MODEL **238, 44**

STOP- AND HEAT SWITCH

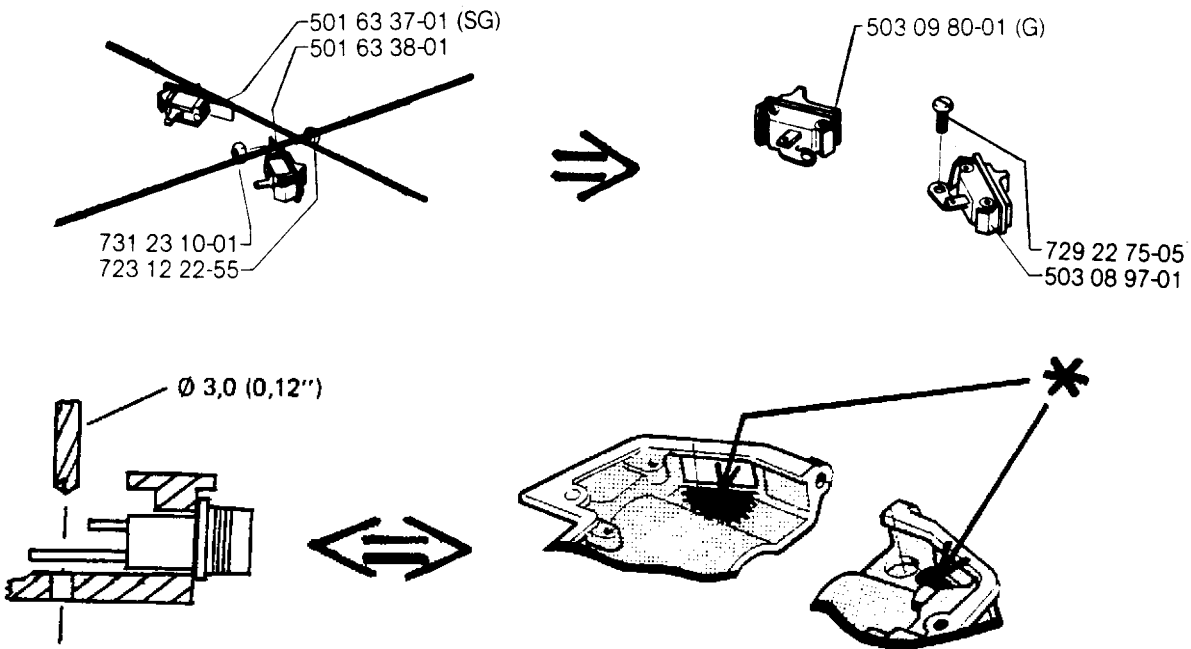
New types of switches have been introduced in our production, according to below.

Crankcases for the model 238 have since 1986 been adjusted to assembly of these switches with a material reinforcement (approx. 1 mm) for screw, according to the marking * below.
